**re: Geotechnical Investigation – Response to Municipality of
Mississippi Mills Comments
Proposed Residential Development
1825 Ramsay Concession 11A- Mississippi Mills, Ontario**

to: Regional Group - **Ms. Stefanie Kaminski** - skaminski@regionalgroup.ca
cc: Novatech - **Mr. Drew Blair** - D.Blair@novatech-eng.com
date: October 2, 2024
file: PG5860-MEMO.04

PROJECT No.	121125-00
REV	REV # x
DRAWING No.	121125-GR1

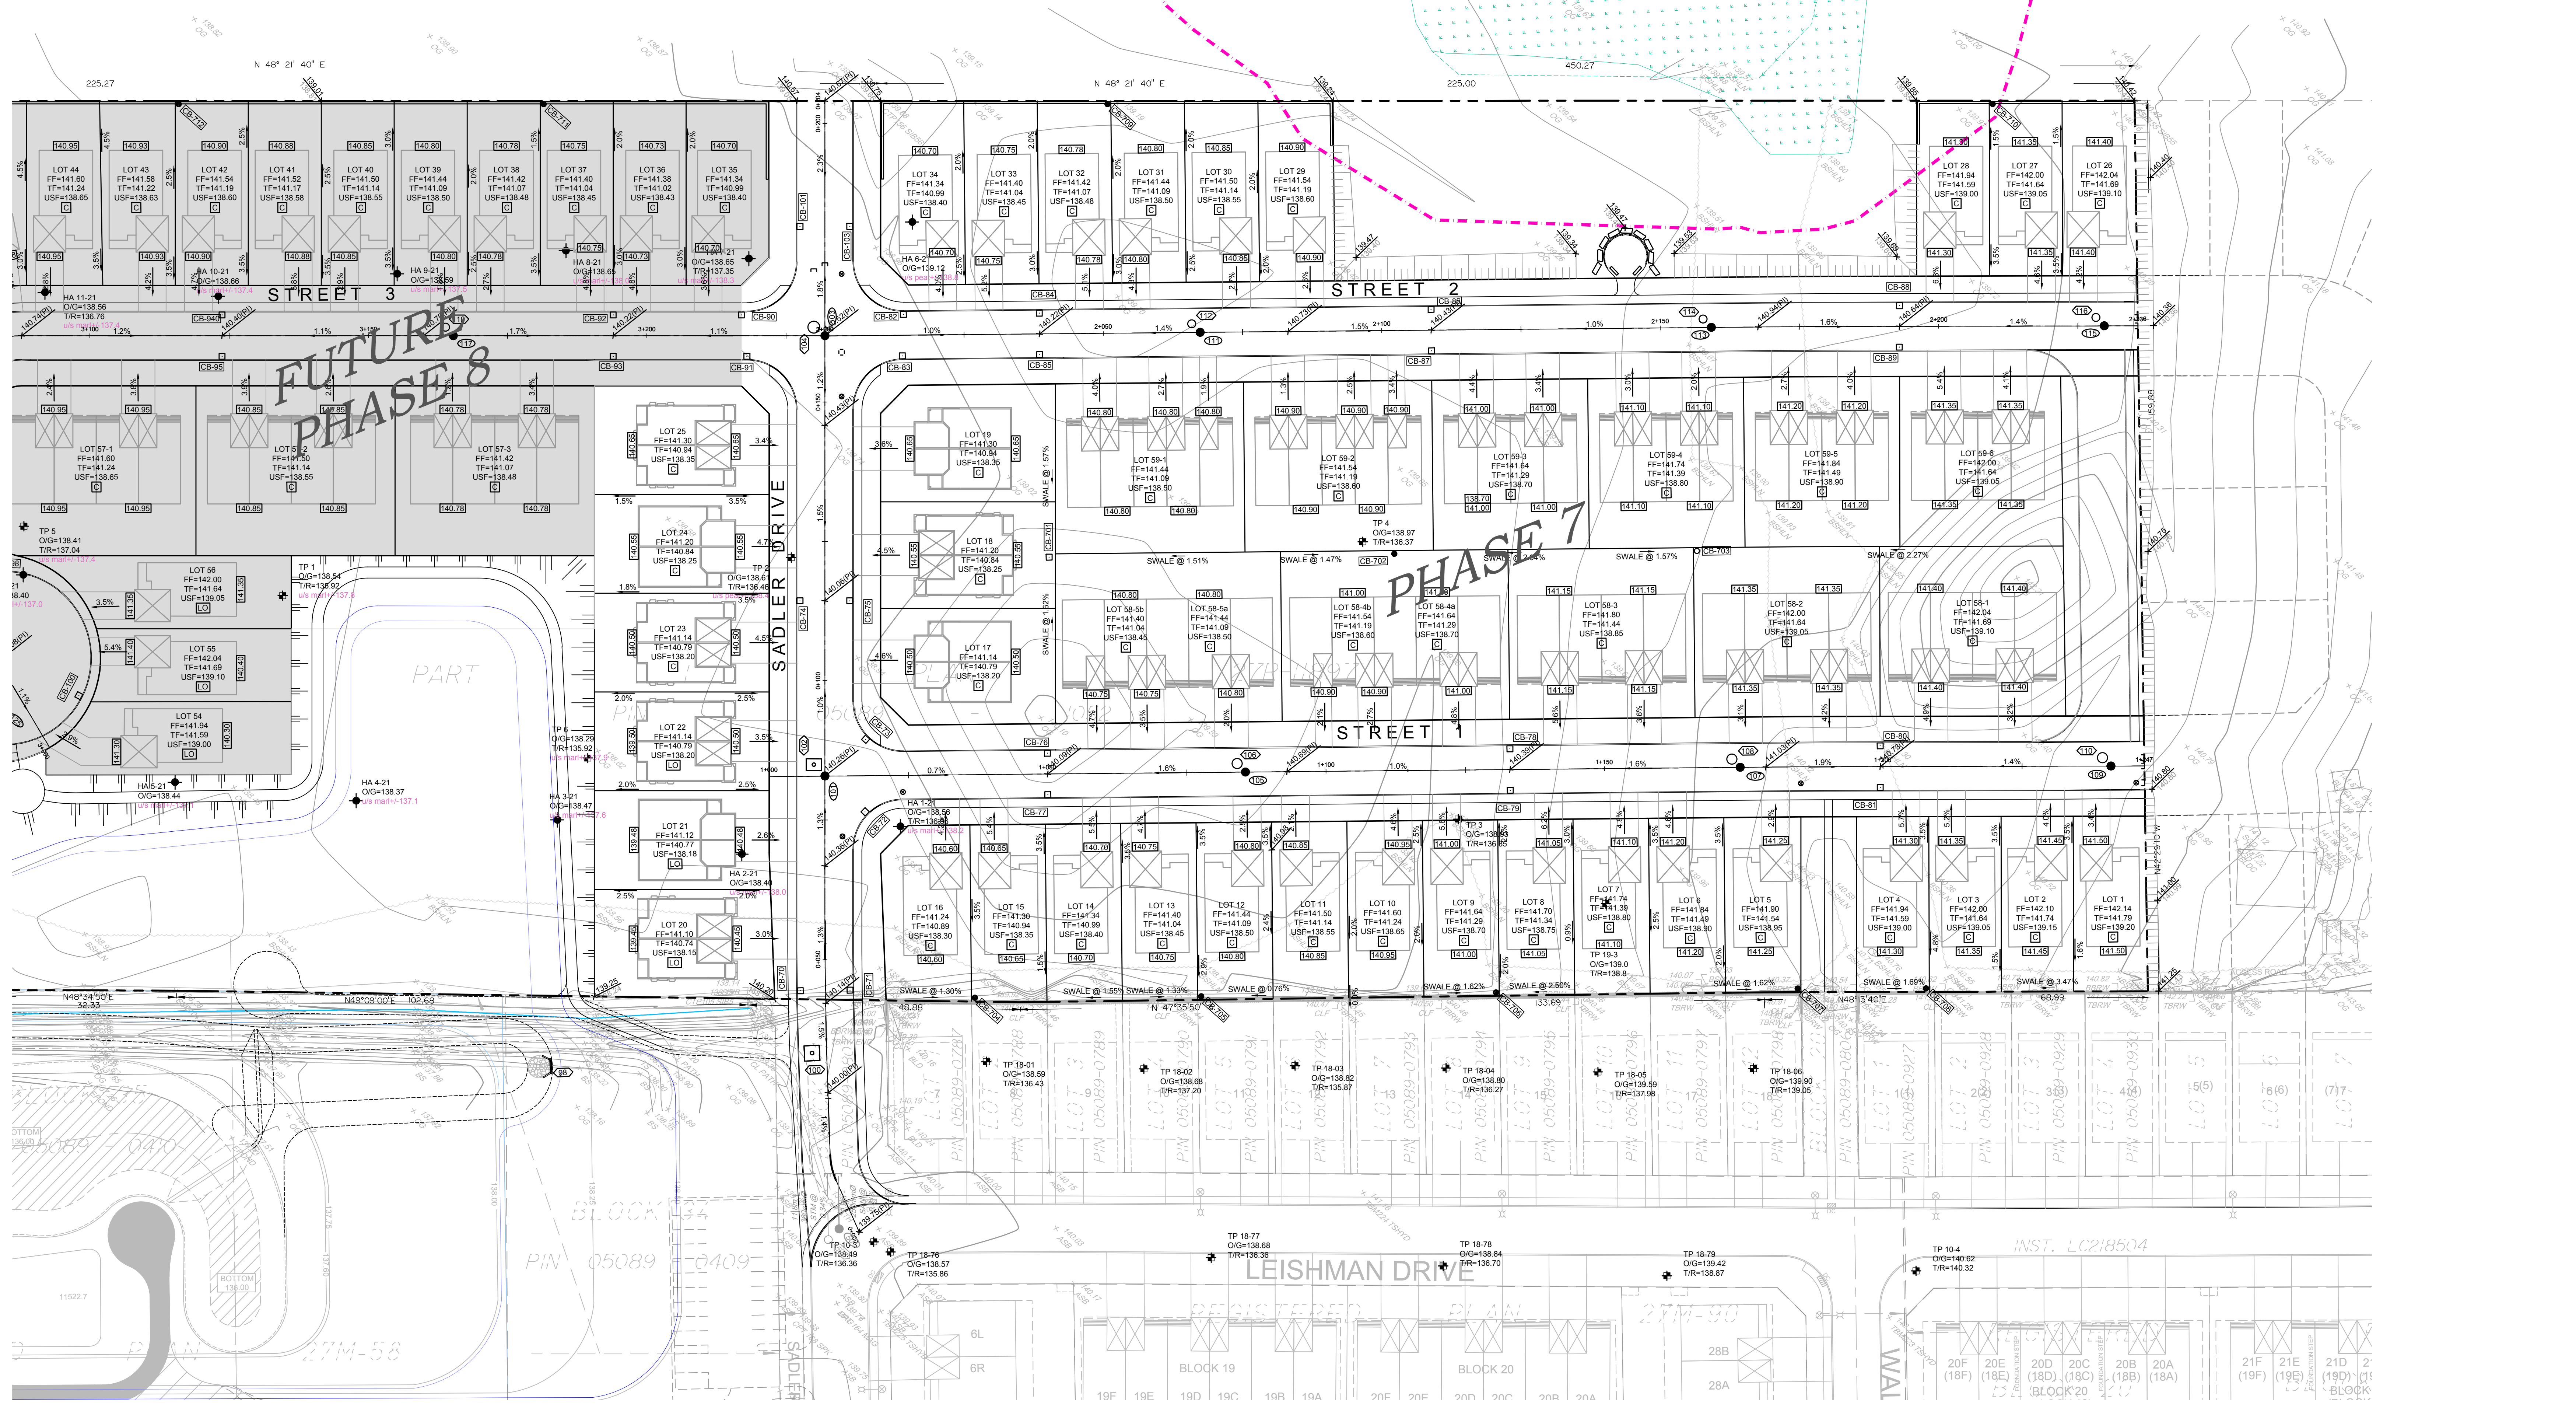
Comment 2: *Can you prepare a plan to indicate which units will be below the seasonal high groundwater level and would warrant a dual sump pump system with a battery-powered secondary pump? It would be helpful to understand if this requirement applies to all units or only a select few based on our current plan.*

Based on reviewing the grading plan Drawing No. 121125-GR1 and GR2 dated September 25, 2024, prepared by Novatech, the units with the proposed USF below the recorded spring high groundwater level are identified in the attached plans

The USF of all the units in Phase 7 are below the groundwater level recorded during the spring high

MUNICIPALITY OF
 MISSISSIPPI MILLS
 MILL RUN EXTENSION
 PHASES 7 and 8
 SUMP PUMP DETAIL

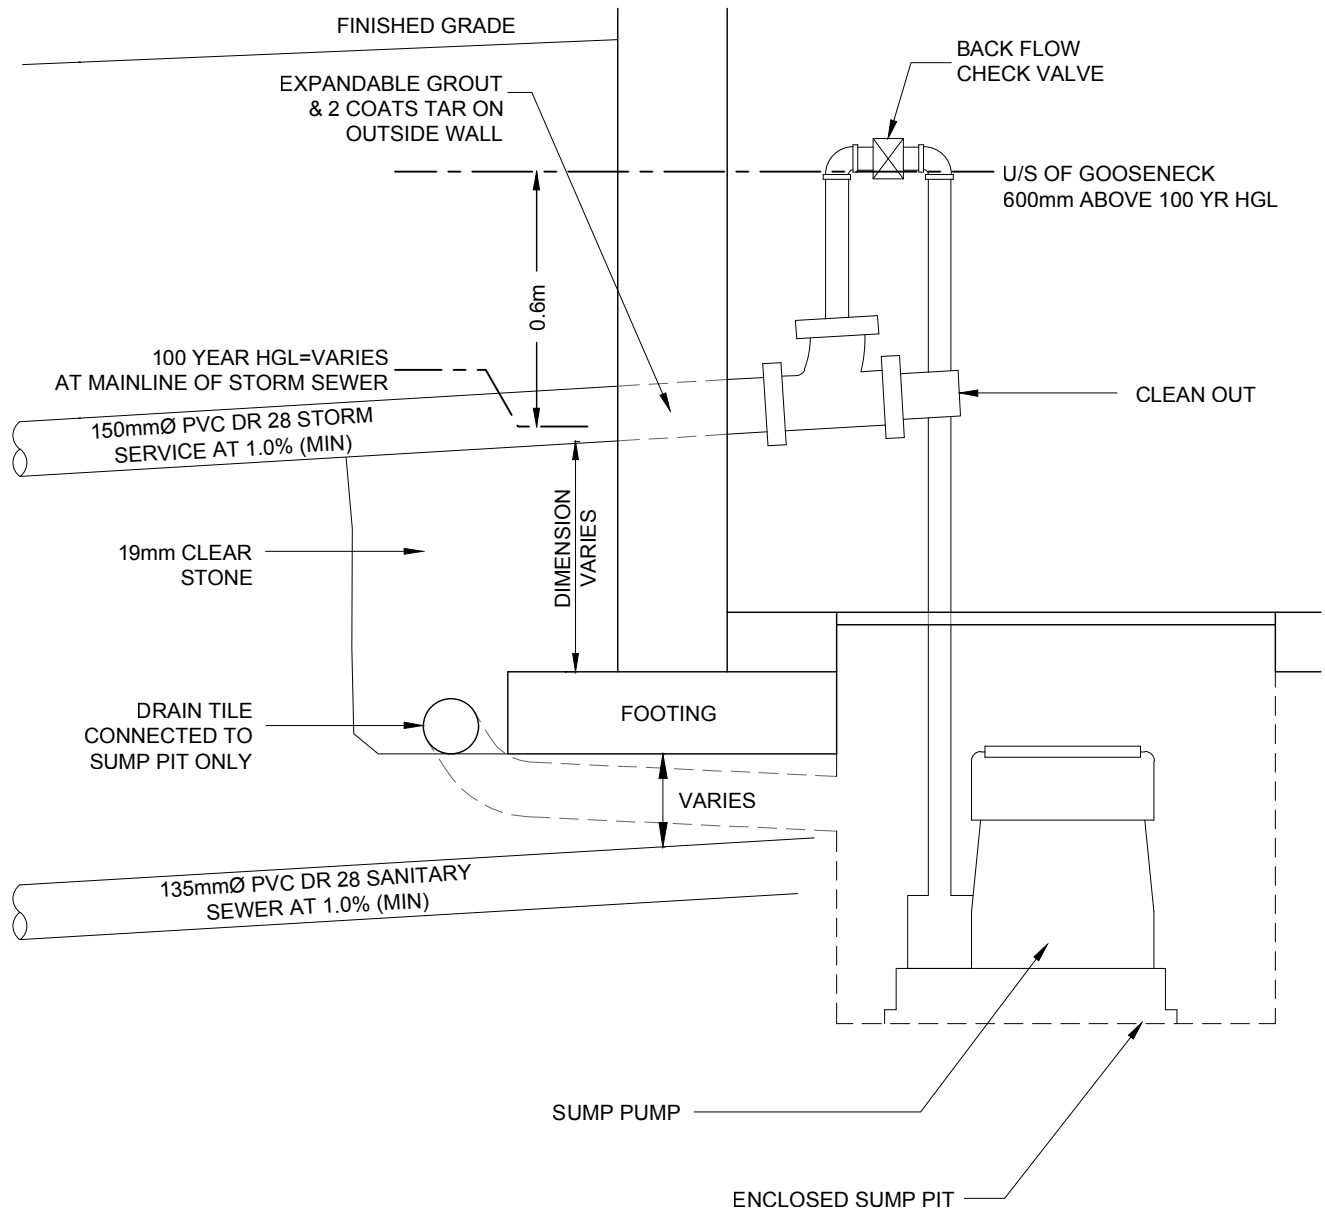
Comment 1: *Can you confirm that Paterson does not recommend the requirement for backup generators for units that will be below the seasonal high groundwater level, and instead dual sump pump system with a battery-powered secondary pump are sufficient?*

As the subsurface soil generally consists of clay material, it is expected that the groundwater infiltration to be minimal. Further, most of the surface runoff will be sheet drained to the catch basin and handled by the storm sewer. Hence, a dual sump system with a battery-powered secondary pump is sufficient upon Paterson completing an inspection on the sump pump installation in each unit. It should be noted that the sump pump system should be installed in accordance with the attached sump pump detail 121125-FIG-SPD dated September 2024, prepared by Novatech.
